Nick Culhane
Highway Consultant

Planning Application F/22/93835

MOORLANDS FARM, BOTLEY ROAD, WEST END, SOUTHAMPTON, SO30 3HD

This Highway Technical Note Addendum has been produced in response to comments made by Hampshire County Council (HCC) and National Highways (NH) on the above planning application in their formal consultation dated 13th October and 25th October 2022 respectively.

Swept Path Tracking

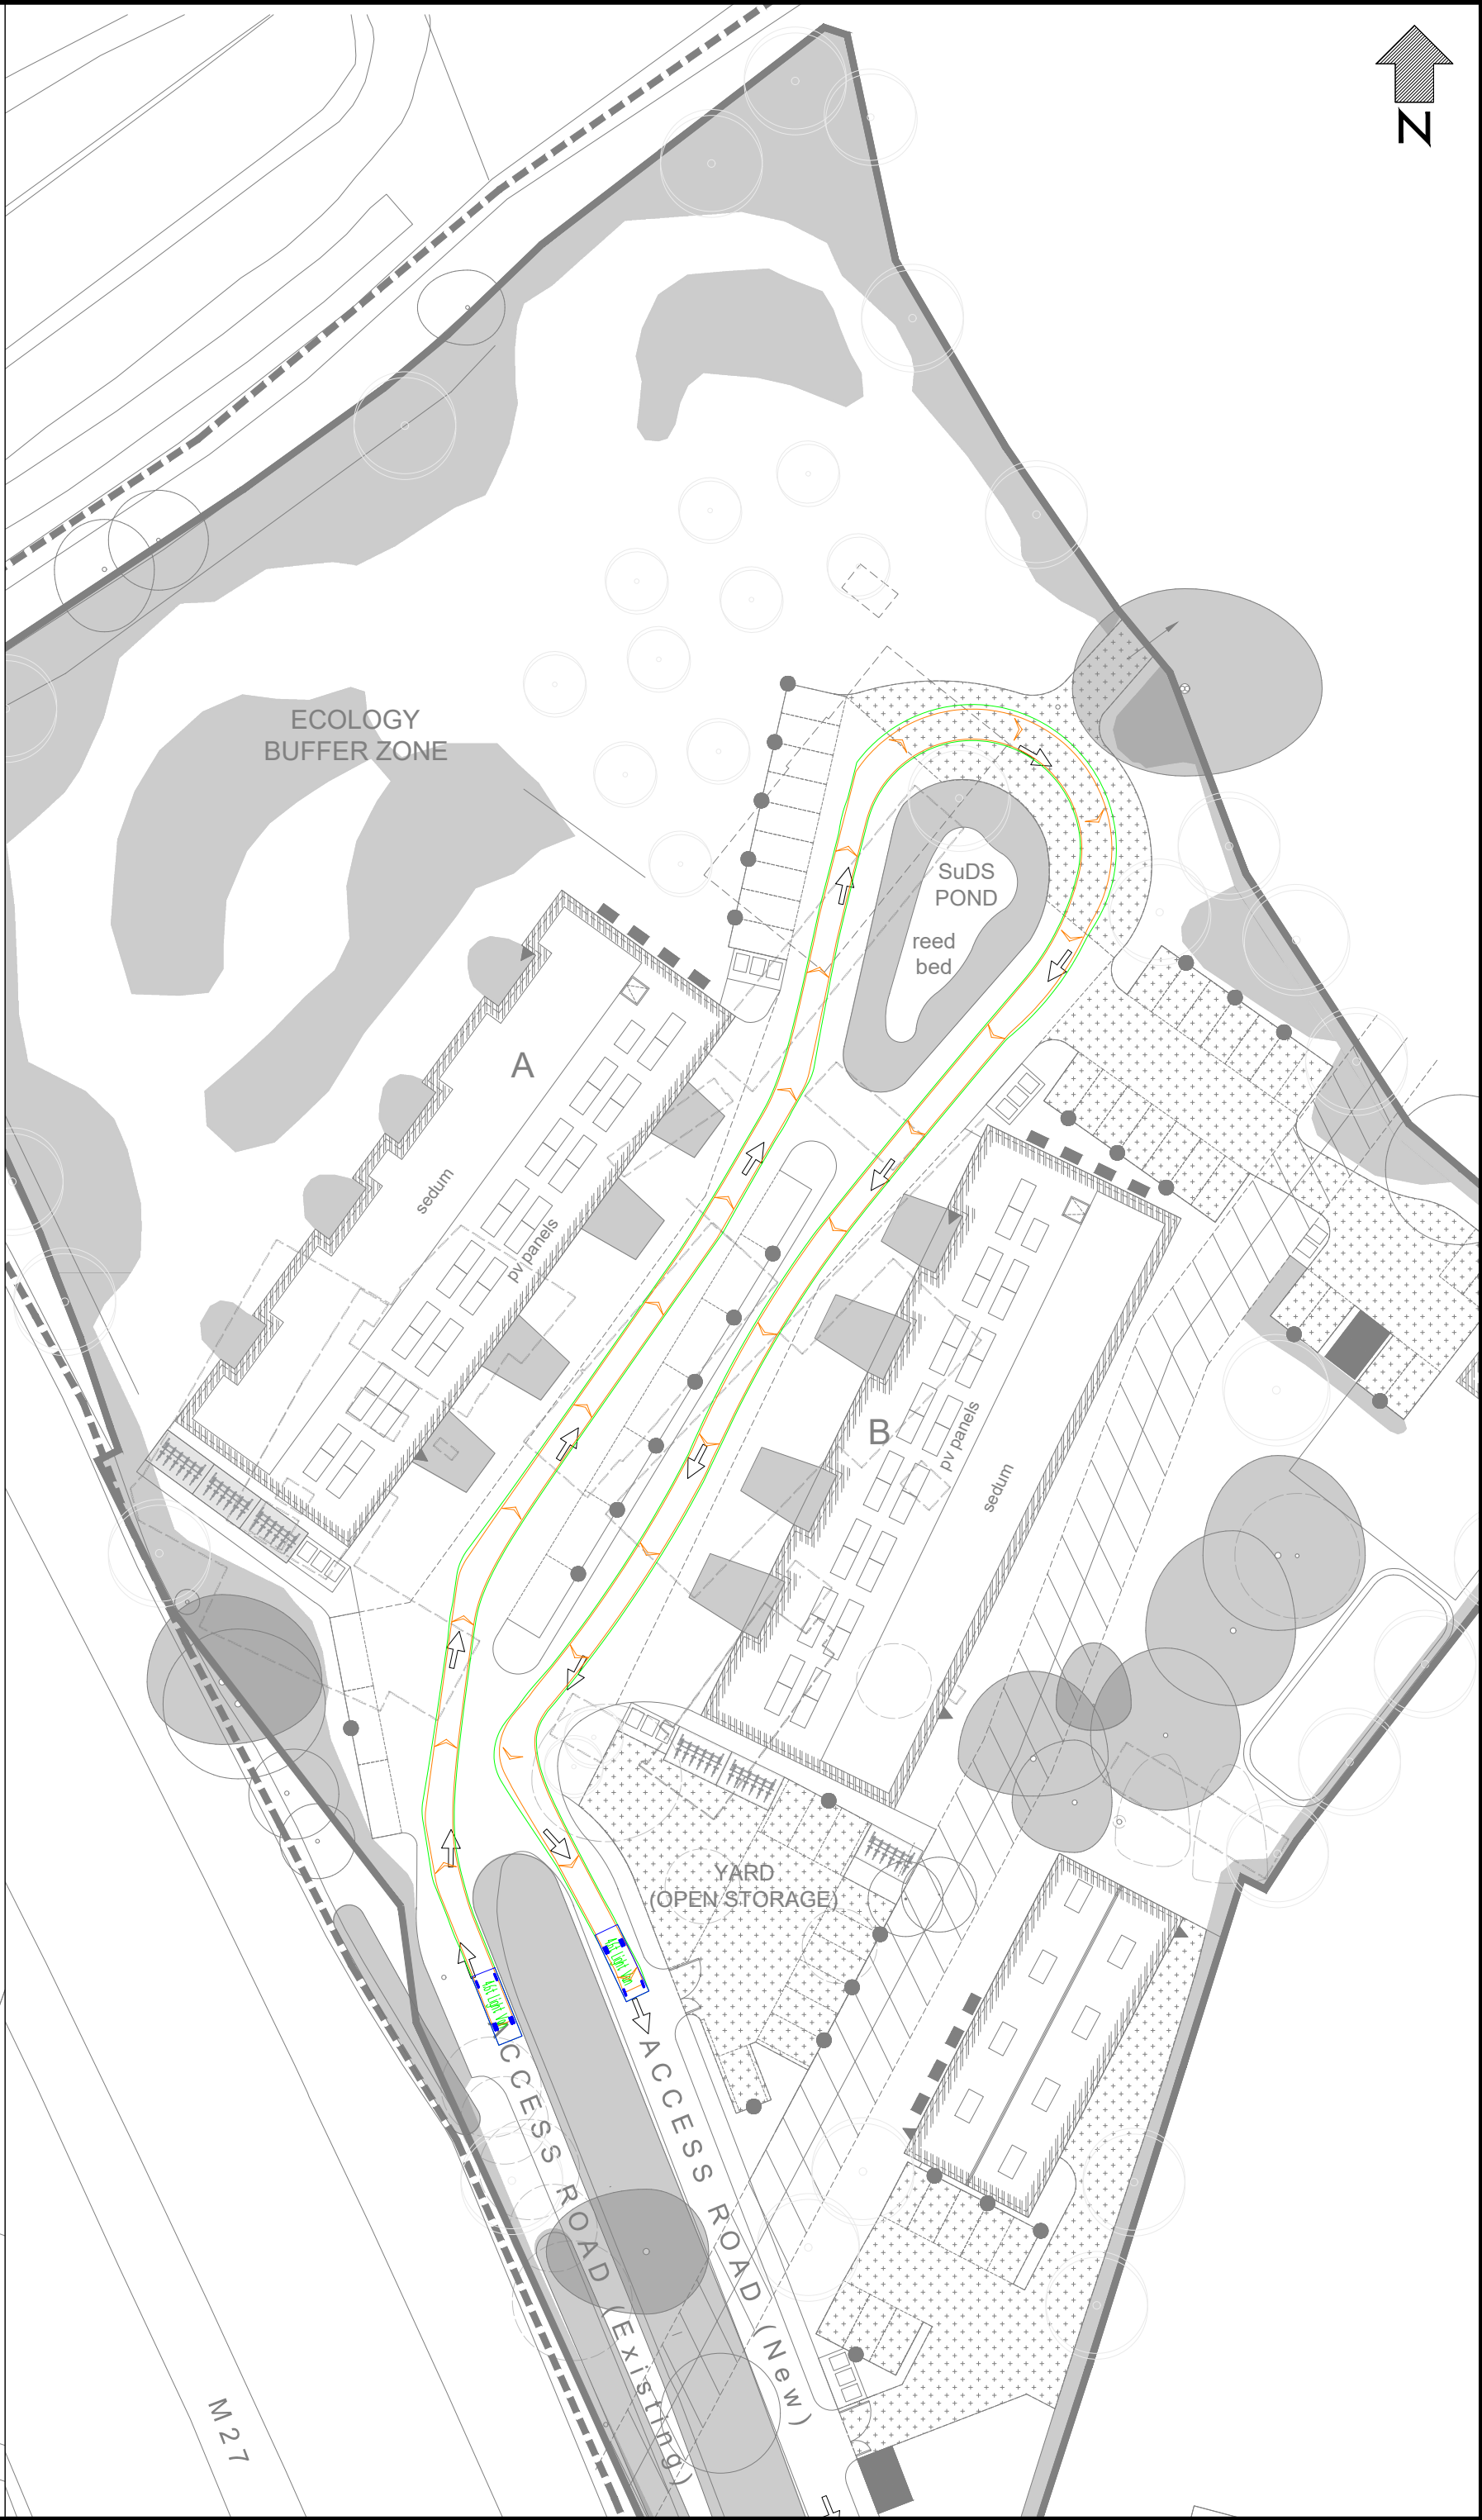
Concern was raised as to the increased use of the existing footway crossing, and potential conflicts with pedestrian and cyclists. Drawing numbered NJC-008 is therefore included as [Appendix 2](#) to this Note which shows the access now redesigned as a formal bell-mouth junction with tactile paving, to aid pedestrians at this point. The drawing demonstrates the principle of the proposal, although a more detailed design including construction details can be formulated as part of a formal Section 278 submission.

It is not anticipated that the site will generate much in the way of articulated vehicles, or HGV traffic in general. It is likely that the majority of traffic will be private cars, or transit type vans. Drawing numbered NJC-009 is included as [Appendix 3](#) to this Note which shows the ability of such vehicles to adequately pass one another along the entire route of the internal access road. The majority of the access road will also allow for such a vehicle and an articulated vehicle to pass one another, although it is recognised that there is a small length between opposing bends in the road where passing may not be possible. Suitable give-way signage will be erected notifying drivers of this situation. In the event that such vehicles do meet, one could reverse to allow the second to pass, which is a common occurrence on many roads throughout the UK. Whilst this may cause some minor inconvenience, there will be no detrimental impacts to highway safety.
